Transportation Impact Study Cruz Landing & Maya Hill Subdivisions Knox County, Tennessee

Revised May 2023

SUBJECT: Response Document for Cruz Landing and Maya Hills Subdivisions TIS Review Comments

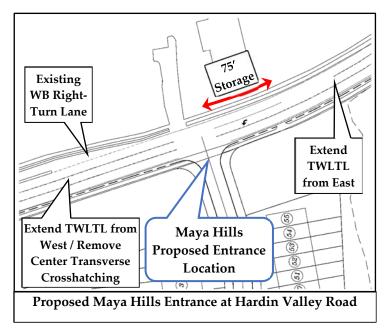
2. Additionally, and regardless of the left-turn lane scenario described in comment #1, there needs to be further description/graphics provided to show how everything ties back in to the west along Hardin Valley Rd since it appears as though some sort of transition/restriping may be necessary where the existing school entrance westbound right turn lane develops in relation to the shifted through-lane geometry that will result near the Maya Hills entrance location. Please also coordinate with the civil engineer to depict the appropriate laneage/striping pattern on a set of updated site plans for our review that also shows locations of access points/public streets on the north side of Hardin Valley Rd for better context.

<u>Response</u>: The proposed layout of the pavement striping on Hardin Valley Road is shown in an image at the bottom of Page 55 and is discussed in recommendation 2a on the same page.

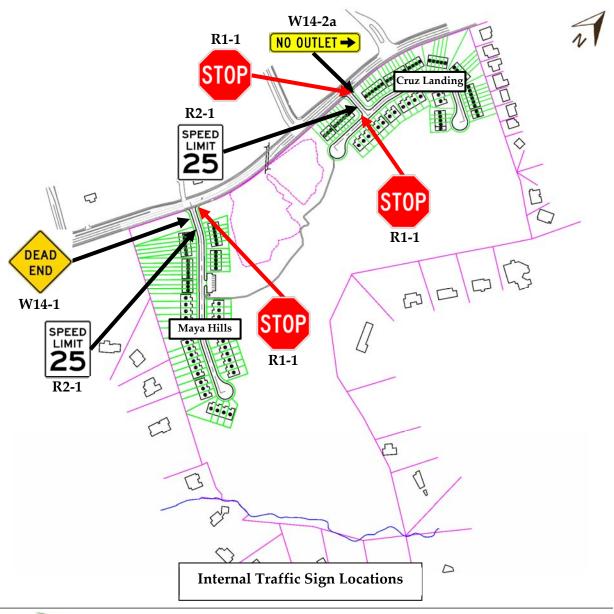
4. Please update the recommendation for "No Outlet" signs to be "Dead End" instead as being the more appropriate sign per the MUTCD. (Later correction by Mike Conger, PE via email: "One slight correction to my comment letter - the "Dead End" sign only applies to Maya Hills with its one cul-de-sac street so that's the only reference that needs to be changed from the "No Outlet" signage.)

Knox County will be requesting the site plan be updated to include traditional cul-de-sacs for the interior streets instead of hammerhead turnarounds so please update any references in the TIS accordingly.

<u>Response</u>: This correction has been made on Page 4, second bullet point, and in recommendation 3a on Page 57. It has also been updated in the image on Page 57.

<u>Response</u>: All references and recommendations for the original hammerhead turnarounds have been removed. The images of the hammerheads were removed from Figure 3 and other figures and references were removed from the document on Page 4, 2nd bullet point; Page 18, 1st paragraph; and on Page 57, recommendation 3a.
